## Amendments for 2025 Service and Installation Rules

## **Empowering South Australia**

2025 SIR Reference	Discussion		Amendment		
Copyright	Updated to 2025	SA Power Ne	tworks Copyright © <del>2023</del> <u>2025</u>		
		Revision Not			
Revision		Date 1 May 2022	Details Complete rewrite of document	Author J Case A Bird	Authorised M Napolitano
Notice	Updated table	1 May 2023	Document updated; please refer to Amendments for 2023 SIR document.	J Case	M Napolitano
		12 May 2025	Document updated; please refer to Amendments for 2025 SIR document.	<u>J Case</u>	<u>A Walsh</u>
	Acknowledgment section This section has been removed as it was relevant for the rewrite of the SIR in 2022	their valuable 	tworks wishes to thank the follow e assistance in the review of these ce of the Technical Regulator (OTR onal Electrical and Communicatio	e rules.  -) n Associat	<del>ion (NECA)</del>
Index	Additional figures and text added	Index has be	en updated		
Table of Figures	Additional figures have been added	Figure numbers have changed

Figure 2 - Clearance to SWER Transformer poles

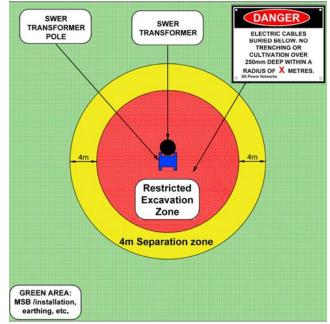
5.10.3	Updated text and added a figure to assist with highlighting the dangers of working in the vicinity of SWER transformer poles.	<ul> <li>5.10.3 Clearances between high voltage distribution earthing systems and low voltage installations (TIR)</li> <li>Customers shall contact SA Power Networks Customer Solutions Manager to provide advice on the earthing system employed and follow the requirements of clause 5.10.1.</li> <li>The distribution network employs either; <ul> <li>multiple earth neutral (MEN), or</li> <li>common multiple earth neutral (CMEN) earthing system.</li> </ul> </li> <li>In areas where a MEN earthing system is used, the clearances between the customer's; <ul> <li>main earth electrode and associated wiring system, or</li> <li>structural metalwork or metallic cladding, which is in contact with the installation earthing system, including switchboards, metering enclosures, generators, opened doors etc., or</li> </ul> </li> </ul>

The location of a MSB and its earthing shall be greater than 4m from the distance that may be specified on the SWER pole signage to ensure clearance from the SWER earthing system. If there is no sign on the pole or a requirement to excavate in the Restricted Excavation or Separation zone, contact the local Customer Solutions Manager.

Distance on SWER pole sign is X metres: Therefore, the clearance for excavations is:

X metres + 4 metres = X+4 metres.

## 7.2.7.1 Customer private Private pole

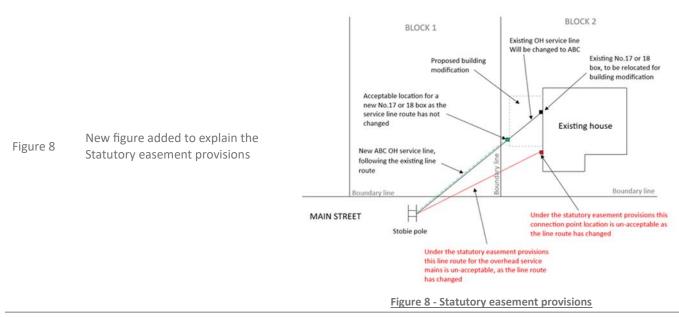
7.2.7.1 To avoid confusion of the ownershipof this pole the terminology has been changed to reflect the pole is owned by the customer

A private pole is a pole owned, supplied and maintained by the customer refer Figure 38 Figure 27 on page 101 and installed within the customer's property. All requirements for access shall comply with clauses 7.2.5.1 and 7.2.7. Refer to 5.9 for maintenance responsibilities.

Figure 14 - Wiring diagram for load limiter installed before the meter

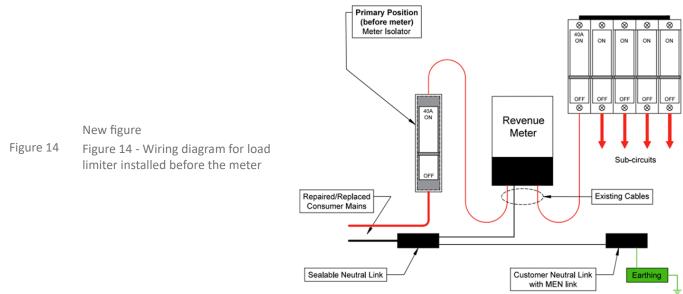
7.9.1	To align with AS/NZS 3000 requirements the term meter isolator has been removed. Only a load limiter is required, which can be installed either before or after the revenue meter. Figures have been added to assist with the understanding	<ul> <li>7.9.1 Repairs to consumer mains relating to size and capacity (less than 100A)</li> <li>Where existing consumer mains are repaired by replacement with larger conductors, to meet modern standards, the work will be considered as a repair and not an upgrade. However, for safety reasons a load limiting device (meter isolator) shall be installed in the customer's installation to the existing service capacity. The load limiting device can be installed either before or after the revenue meter, as shown in Figure 13 and labelled as SAPN LOAD LIMITIMG DEVICE.</li> <li>Where increase in authorised service capacity is required, the upgrade of consumer mains and/or load control device shall be through the alteration process.</li> </ul>

Figure <u>19</u>10 – MSB/group meter board clearances and egress paths for nondomestic and multiple installations

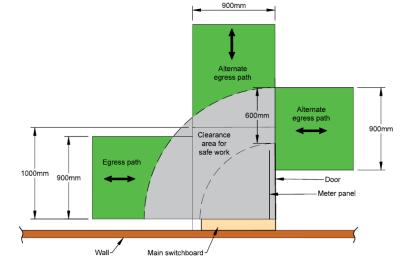
Removed reference to "space requirements" from the MSB to a wall

Figure number has changed due to additional figures added

8.1.4	Figure reference has changed due to other figures being added	MSB/group meter board, including the doors, in any open position, shall be maintained as shown in the Figure $1019$ . For MSB/group meter boards with removable lift off doors a minimum clearance of 1000mm shall be maintained from the MSB/group meter board.

Figure 28 - Additional protection – Internal View

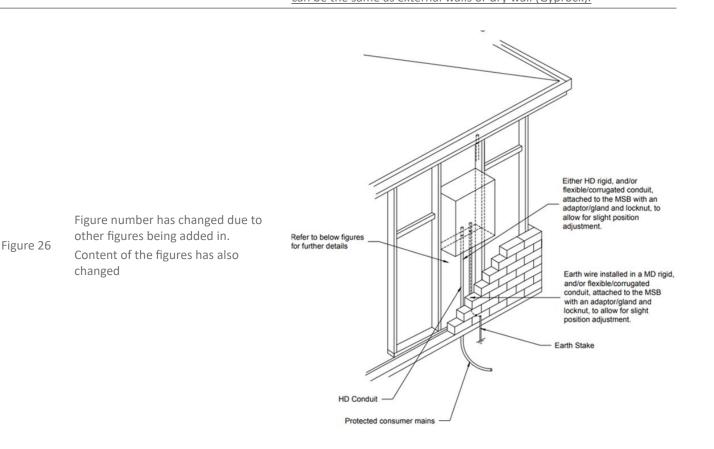
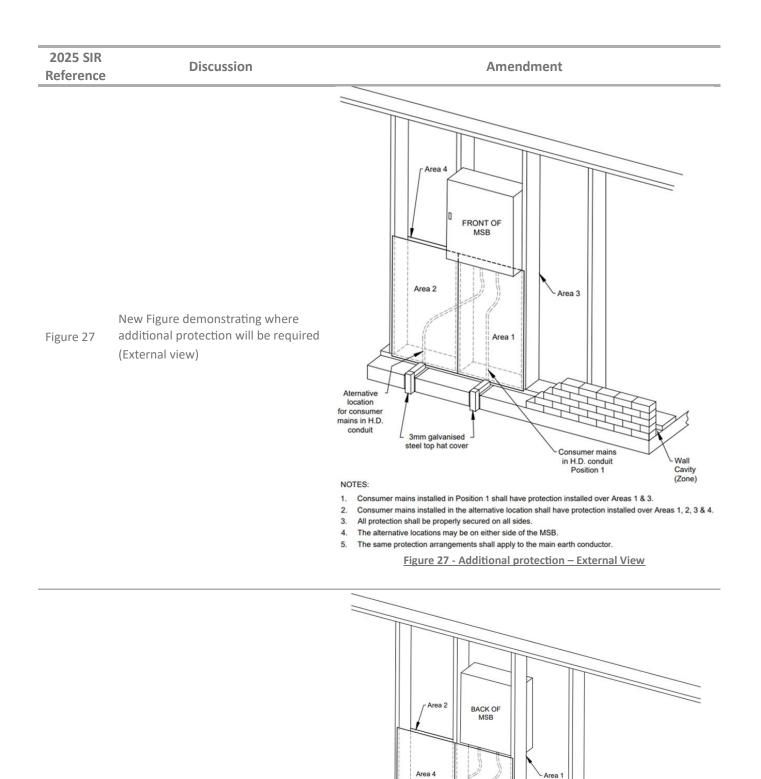
New Figure demonstrating where additional protection will be required Figure 28 (Internal View

Notes:	
		* The additional protection for external walls can be timber ply,	
		cement sheet, builders wrap or other non-conductive ridged	
		weather-proof material. For internal walls, the additional protection	
		can be the same as external walls or dry wall (Gyprock).
